Access Compliance Report

Public Rights-of-Way

(Transit Stops)

Intersection ID: 10020327	Main Street: BALDWIN_AV	Cross Street: N/A	Location: S
ADA ID: 836352F485B5	Overall Compliance: No	Severity Score: 35	
Codes/Mitigation Info/Possible Solution		Field Measurements/Component Compliance

CATS Stop Description: **Baldwin Ave & Kings Dr**

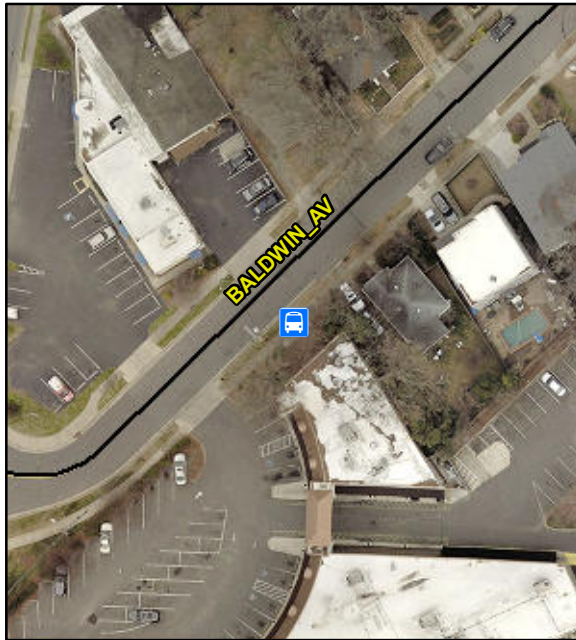
**Remove & Replace Boarding Area.
Remove & Replace Sidewalk To
Boarding Area. Remove & Replace
Clear Floor Space.**

**305.2, 402.2, 810.2.3, 810.2.4, 810.3,
R302, R302.5, R308.1.1.2, R404.1,
R404.2**
